PRELIMINARY OVERALL AREA DEVELOPMENT PLAN

PATOIL CORPORATION

CITY OF SAN ANTONIO
POADP APPLICATION

Re: Patoil Corporation POADP # 609

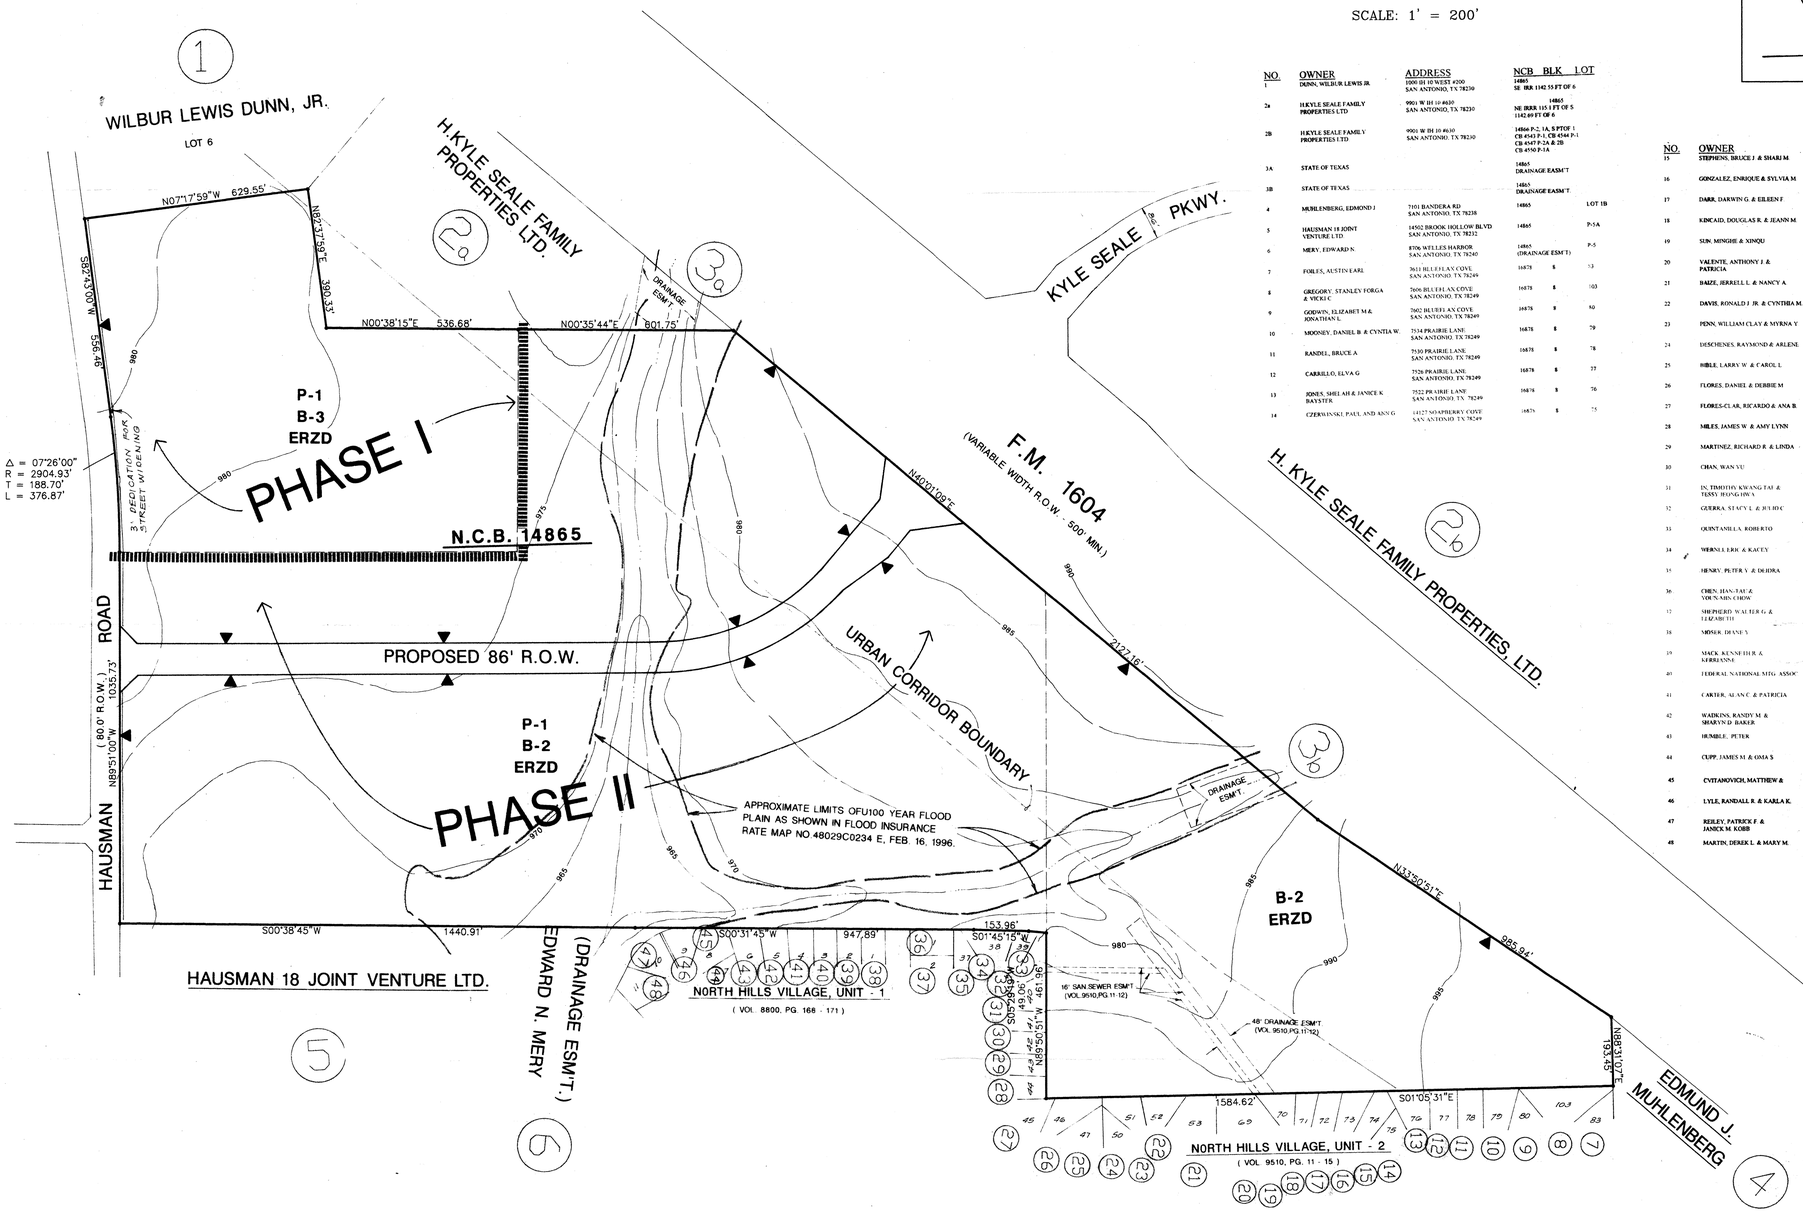
The City Staff Development Review Committee has reviewed Patoil Corporation Subdivision Preliminary Overall Area Development Plan # 609. Please find enclosed a signed copy for your files. Although your plan was accepted, please note the following:

- Based on the topography, a Flood Plain Study and drainage review will probably be required during the platting process.
- This development will probably need to conform to requirements associated with development over the Edwards Aquifer. For additional information about these requirements you can contact SAWS at 704-7305.

- Access and ROW issues along State facilities will need to be resolved with the Texas Department of Transportation. For information about these requirements you can contact TXDOT at 615-5814.

- This development will need to comply with tree preservation ordinance #85262. For information about these requirements you can contact Building Inspections at 207-7102.

- It will be expected that you will plat all of the property depicted in your POADP, to include: floodpains, drainage areas and open space.
- I would encourage you to work closely with the school district, so that they can plan accordingly.

Comments: 1. Row of Hausman is 86'
2. TIA

Comments: FLOOD PLAIN REQUIREMENT AND DRAINAGE EASEMENT WILL BE REQUIRED AND ADDRESS DURING THE PLATTING PROCESS

P.O.A.D.P. Reviewed for:	Comments
Noise Mitigation	For residential development directly adjacent to State ROW, the developer shall be responsible for adequate set-back and/or sound abatement.
R.O.W. Requirements	None
Access Limits/Restrictions	Maximum of 14 access points. Locations will be as directed by "Regulations For Access Driveways to State Highways".
WPAP Requirements	None

ADDITIONAL COMMENTS: The proposed intersection of the planned roadway and Kyle Seale Parkway depicted on the P.O.A.D.P., appear to have offset centerline alignments. To ensure proper (non-offset) alignment of the proposed roadway, intersection layouts of the recently completed Loop 1604/Kyle Seale interchange may be obtained from the Texas Department of Transportation.

- Section 35-2071 of the Unified Development Code (UDC) states that interior circulation must be included on the Plan. Such circulation includes both public and private "circulation". By interpretation this applies to access easements, private drives, private streets and "all" curb cuts for access to public streets.
- POADP status is granted to properties being subdivided into two or more units. Single lot subdivision do not meet the intended purpose of phased development and shall not receive POADP plan approval.

Please find attached ten (10) copies of the revised Preliminary Overall Area Development Plan (POADP) of the Patoil Corporation tract. These are resubmitted per comments dated July 31, 1997 by Mr. William Telford, a copy of which is attached.

We have included the access points where private drives are most likely to occur. These location points are consistent with that as shown on the Traffic Impact Analysis (TIA) report prepared by Carter & Burgess, Inc. on December 1, 1997. The TIA is currently being reviewed by Amer Gilani of the Traffic Division of the Department of Public Works. Based on the current zoning classification of the property, ultimate development will be Business and/or Office Parks. There are no specific site plans available at this time, however, private driveways will be limited to the location shown on the plans. Ultimately, all driveway specific locations will be reviewed either by the Texas Department of Transportation or the Department of Public Works during the final platting process.

The POADP will be divided into two units or phases. Phase I includes the P-1 B-3 ERZD area at the southwest corner of the tract. Phase II includes the remaining portion of the POADP and the improvements of the 86-foot right-of-way secondary street from FM 1604 to Hausman Road.
